## Model Administrative Change Notice

1. Document Number:	MDL-NBS-HS-000020	2. Revision:	02/AD01	3. ACN:	01
4. Title:	Particle Tracking Model and Abstraction of Transport Processes				
5. No. of Pages Attached	6

Figure 6.8.2-5. Mean Travel Time of  $^{237}\text{Np}$  as a Function of Matrix Diffusion Coefficient and Sorption Coefficient for the Glacial-Transition Climate Condition, DFM Model, Northern Release Location

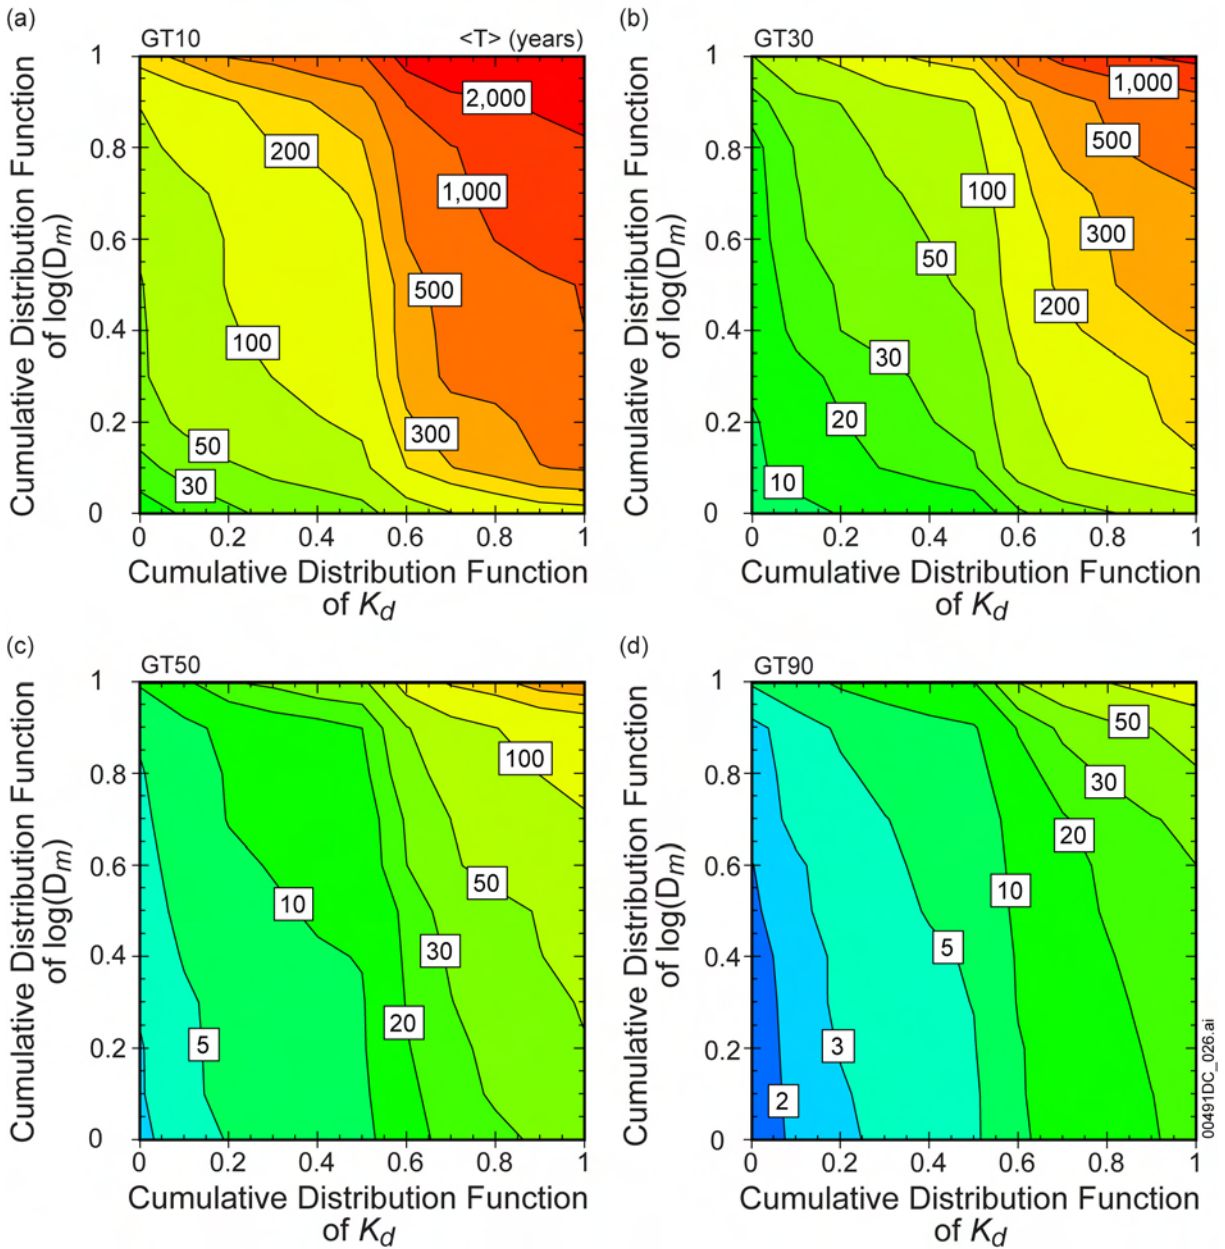
Page 4-10, last paragraph, 1st line	Section 4.1.6 Replaced "tracer test" with "tracer tests"
Page 6-46, Figure 6.8.2-5	Section 6.8.2.1 Change made in the text above the plots: changed "dual-k" to "DFM"
Page 6-53, 2nd paragraph, 4th line	Section 6.8.2.2 Changed "90%" to "approximately 99.3%" in the document
Page 6-67, 1st and 2nd line:	Section 6.8.2.2 changed "(left)" to "(top)", and changed "(right)" to "(bottom)"
Page 7-15, Figure 7-12	Section 7.2.3.2 Inserted "of" after "Role" in the figure caption
Page 8-20, 2nd paragraph, 5th line:	Section 8.2.2 Inserted "a" before "very minimal barrier"

$^{237}\text{Np}$ , DFM, node 39713(N)
